Flood Damage Reduction Segment / System Inspection Report

Name of Segment / System: Souris River-Burlington to Minot-TierrecitaVallejo

Type of Inspection:	<input type="checkbox"/> Initial Eligibility Inspection <input checked="" type="checkbox"/> Continuing Eligibility Inspection (Routine) <input type="checkbox"/> Continuing Eligibility Inspection (Periodic)	Overall Segment / System Rating:	<input type="checkbox"/> Acceptable <input type="checkbox"/> Minimally Acceptable <input type="checkbox"/> Unacceptable
Contents of Report:	<input checked="" type="checkbox"/> Instructions <input type="checkbox"/> Initial Eligibility Inspection <input checked="" type="checkbox"/> General Items for All Flood Control Works <input checked="" type="checkbox"/> Levee Embankment <input type="checkbox"/> Concrete Floodwalls <input type="checkbox"/> Sheet Pile and Concrete I-walls <input checked="" type="checkbox"/> Interior Drainage System <input type="checkbox"/> Pump Stations <input checked="" type="checkbox"/> FDR System Channels	<p>Note: In addition to the report contents indicated here, a plan view drawing of the system, with stationing, should be included with this report to reference locations

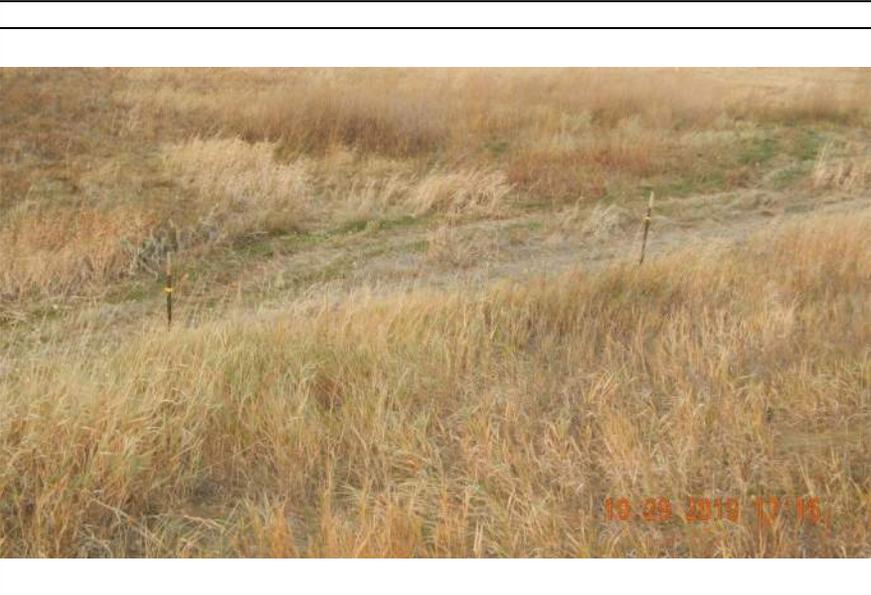
<p>Inspect ID: BMTV_2019_a_0014 Title: USACE_CEMVP_BMTV_2019_a_0014_1.jpg Rated Item: 1. Unwanted Vegetation Growth Caption: Rating: Unacceptable; Remarks: Unwanted Vegetation Growth. Trees (>2 inches in diameter) and long vegetation located on landside levee slope. ; Action: Remove unwanted vegetation from vegetation-free zone, up to the levee easement; Remove root ball, backfill, compact in lifts, and re-sod; Ensure environmental compliance with all appropriate agencies prior to removal; Station_1: -5+66; Station_2: 2+42</p>
	<p>Inspect ID: BMTV_2019_a_0014 Title: USACE_CEMVP_BMTV_2019_a_0014_2.jpg Rated Item: 1. Unwanted Vegetation Growth Caption: Rating: Unacceptable; Remarks: Unwanted Vegetation Growth. Trees (>2 inches in diameter) and long vegetation located on landside levee slope. ; Action: Remove unwanted vegetation from vegetation-free zone, up to the levee easement; Remove root ball, backfill, compact in lifts, and re-sod; Ensure environmental compliance with all appropriate agencies prior to removal; Station_1: -5+66; Station_2: 2+42</p>

<p>Inspect ID: BMTV_2019_a_0022 Title: USACE_CEMVP_BMTV_2019_a_0022_1.jpg Rated Item: 1. Unwanted Vegetation Growth Caption: Rating: Unacceptable; Remarks: The federal project ties into a discontinuous emergency embankment at the upstream extent of the project; Action: An evaluation of the profile is necessary to define the line of protection and required closure heights and extents for varied flow events; Station_1: NA; Station_2: NA</p>
	<p>Inspect ID: BMTV_2019_a_0023 Title: USACE_CEMVP_BMTV_2019_a_0023_1.jpg Rated Item: 1. Unwanted Vegetation Growth Caption: Rating: Unacceptable; Remarks: Overgrown grass, large dense tree cover, and brush cover the levee crown, slopes, toes, and vegetation-free zone; Action: Remove unwanted vegetation from vegetation-free zone, up to the levee easement. Remove root ball, backfill, compact in lifts, and reseed with grass. Ensure environmental compliance with all appropriate agencies prior to removal; Station_1: 7+67; Station_2: 9+84</p>
